## International Dart Rules Committee

### 9<sup>th</sup> May 2011 Tiller Bar Adjustable End.

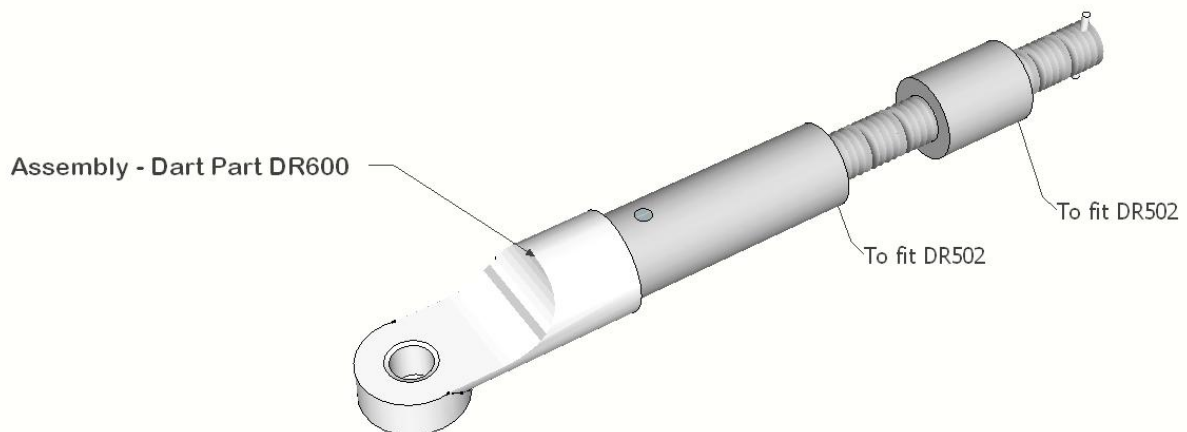
1. Tiller connecting bar tube comes in fixed length from the manufactures at 5m lengths. This means the Licensee can only get 2 connector bars from one length whereas with the addition of an adjustable fitting 3 lengths can come from a 5m piece thus reducing costs.
2. There is now a bit more variation in tillers and bars that means rudder alignment is extremely difficult to achieve without major surgery.

An adjustable fitting has been devised to facilitate the alignment of rudders and has been approved by the IDRC under rule 6 of the Constitution.
